## PHOTOGRAPHS

**PHOTOGRAPH #7**

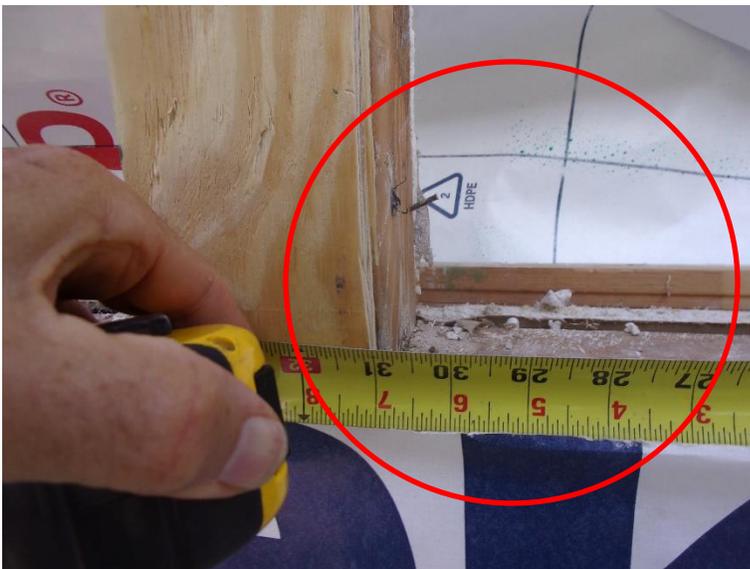
Window dimensions confirmed to meet window manufacturer's NOA requirements and **ESI # 4**.

**PHOTOGRAPH #11**

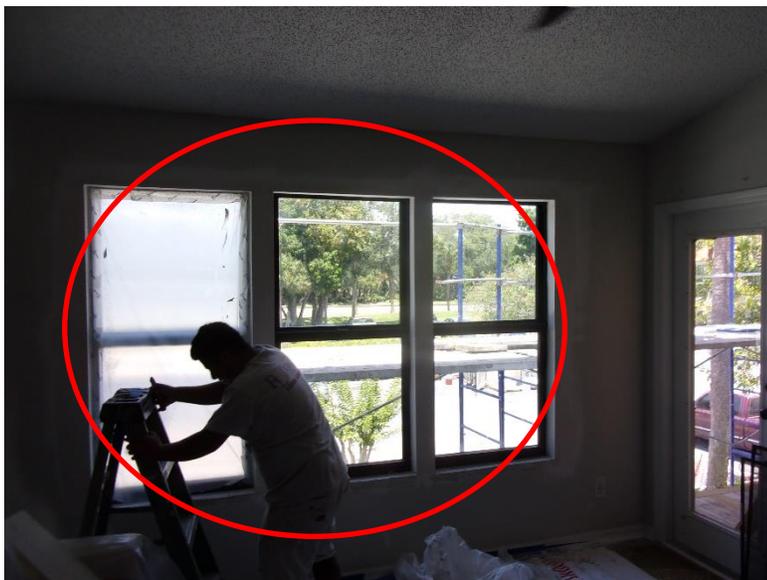
New PGT window installed, and flashing performed with DuPont Tyvek flashing system.

**PHOTOGRAPH #13**

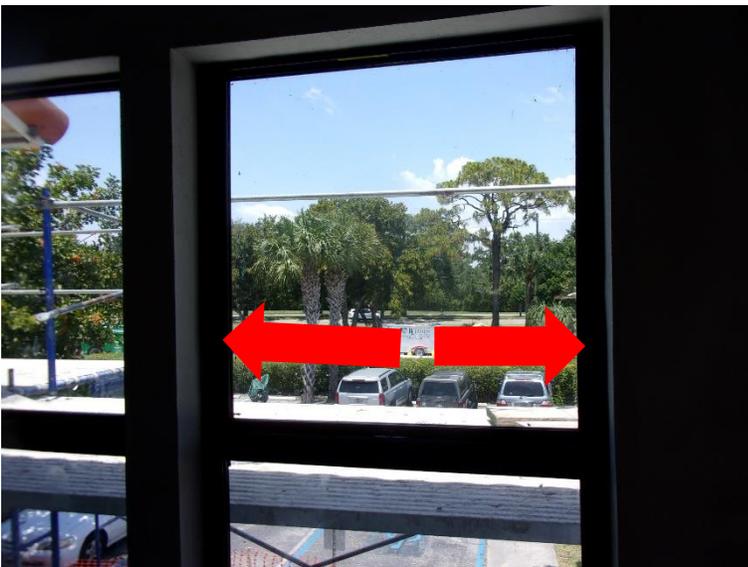
**Unit #228-** New urethane sealant applied at interior side of window frame to Tyvek flashing.
